**ADDENDUM NO. 3  
February 5th, 2026**

**INVITATION FOR BID (IFB)  
IFB NO. 2025-12  
RADON MITIGATION VARIOUS SITES**

This addendum to subject IFB, is a result of drawing and specification updates that occurred after the issue of the IFB dated January 12<sup>th</sup>, 2026. Additional questions are expected, but none are addressed in this addendum. The additional questions will be responded to in a follow-up addendum.

DRAWING NO.  
**A-105.1**

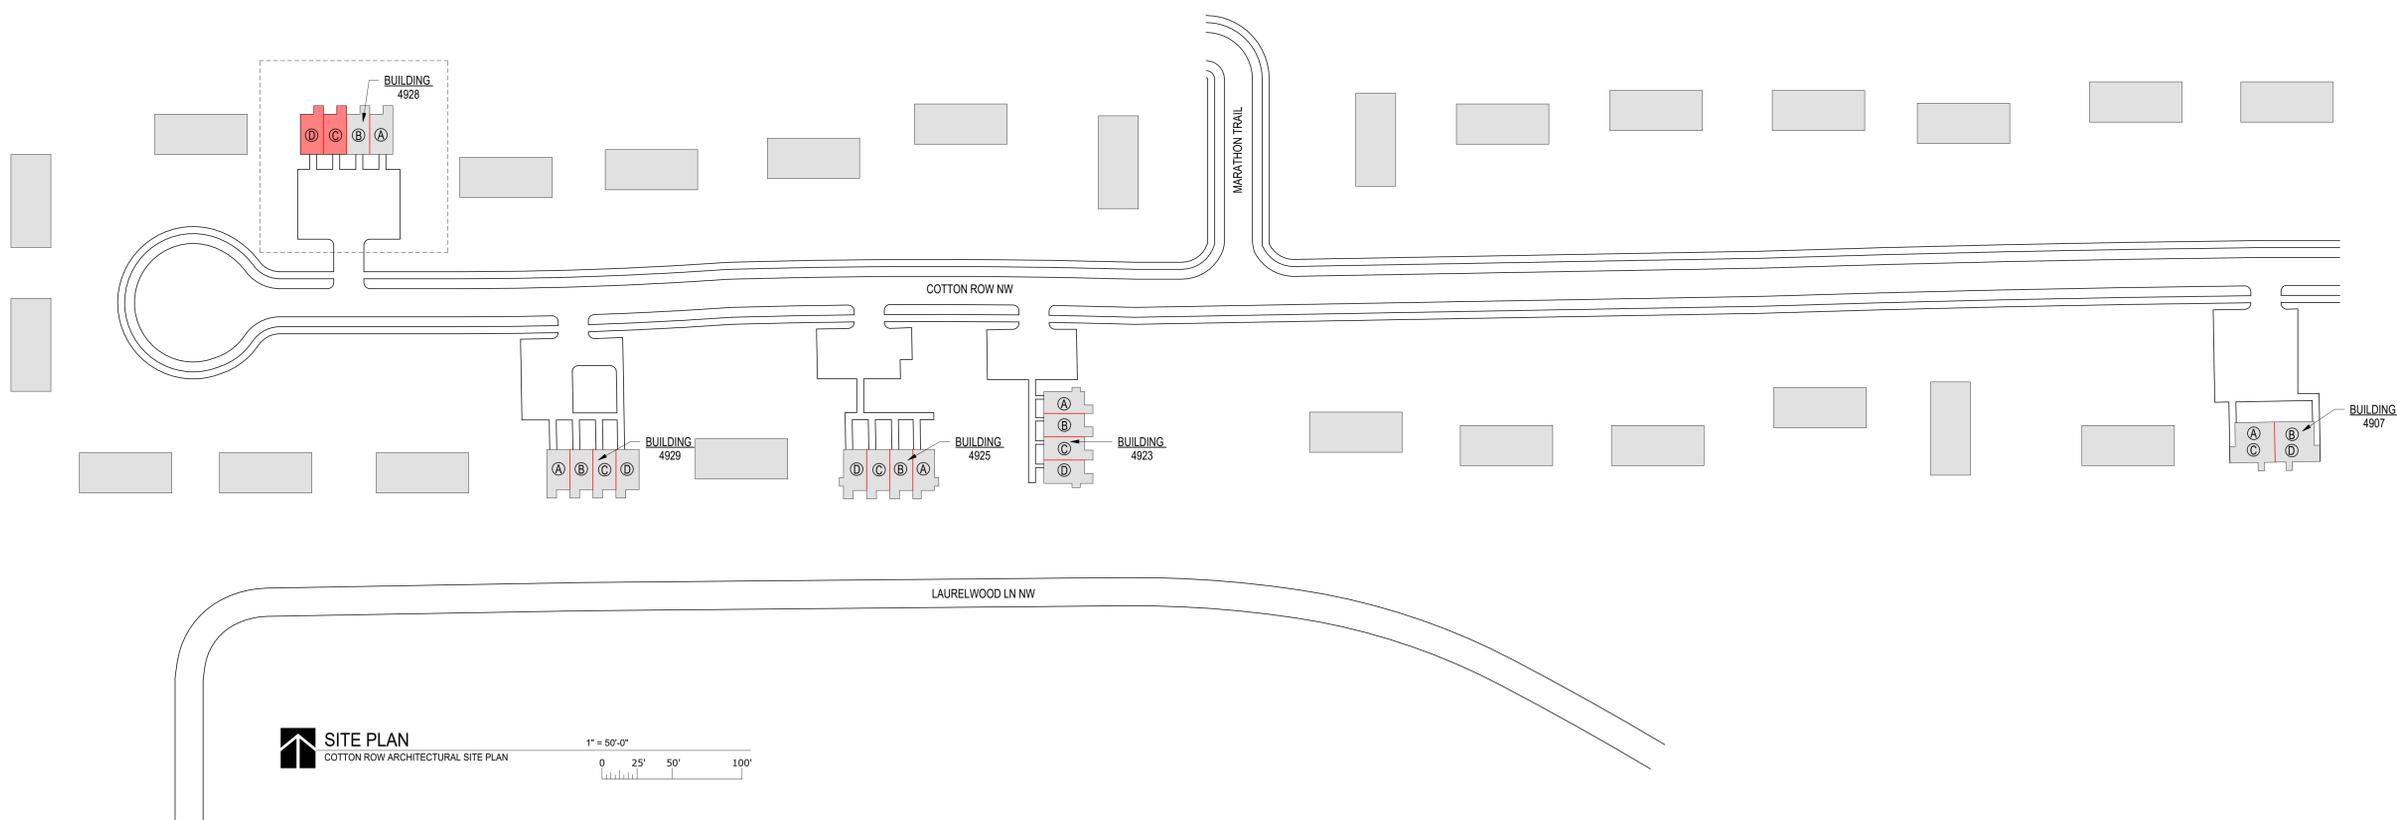
**Clarification 3.15:** *Sheet A-105.1 – Updated legend definitions. The work involves units that that tested above 4.0 pCi/L.*
